**SB-GA8-2023-215**

**Issue 3**

# Service Bulletin

Blower Fan Repair or Replacement

**Figure 3: Order of Assembly**

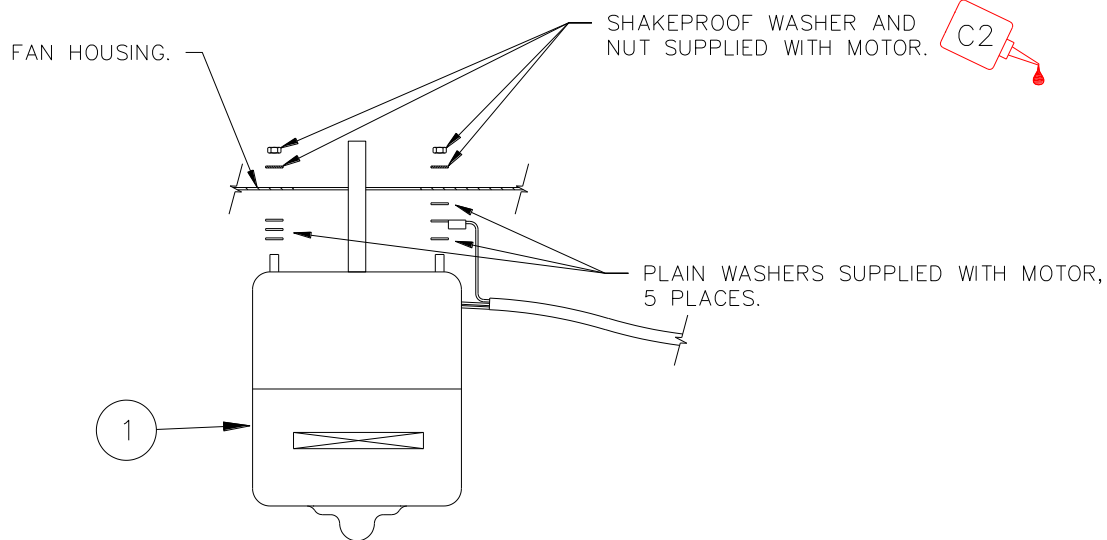
7. Inspect the fan wheel for corrosion or cracking. Discard if damage is found.
8. From Table 5 ensure that the correct fan motor is being installed, then reassemble the fan to the Replacement Motor:
  - i. Order of assembly of the motor to the housing is shown in Figure 3. Apply Compound C2 (Table 7), in accordance with the manufacturer's directions, to the attachment nuts.
  - ii. Centre the fan inside the housing (i.e. slide it up and down the shaft until it has equal clearance on top and bottom; DIM A = DIM B, per Figure 4).
  - iii. Position the existing P/No. GA8-212022-021 Modified Fan Stiffeners so that the motor shaft is perpendicular to the housing, per Figure 4.
  - iv. Apply Compound C2 (Table 7), in accordance with the manufacturer's directions, to secure the grub screw holding the fan to the motor shaft.

**Figure 5: Replacement Fan Installation**

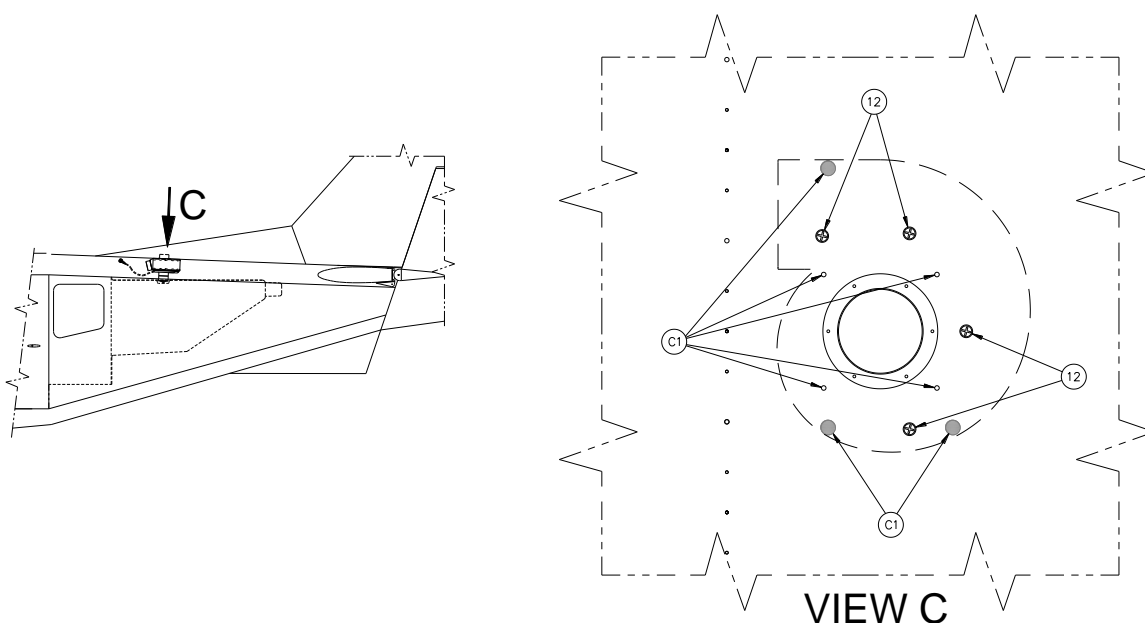
6. Remove the 8 screws holding the fan to the upper tail cone skin. Remove the fan assembly from the aircraft.
7. Install the new Blower Fan (Item 11 of Table 6) using 4 screws (Item 12 of Table 6) as shown in Figure 5. Seal the 4 un-used holes and apply three  $\text{\O}0.5''$  beads of sealant, Compound C1 (Table 7) at the locations shown.
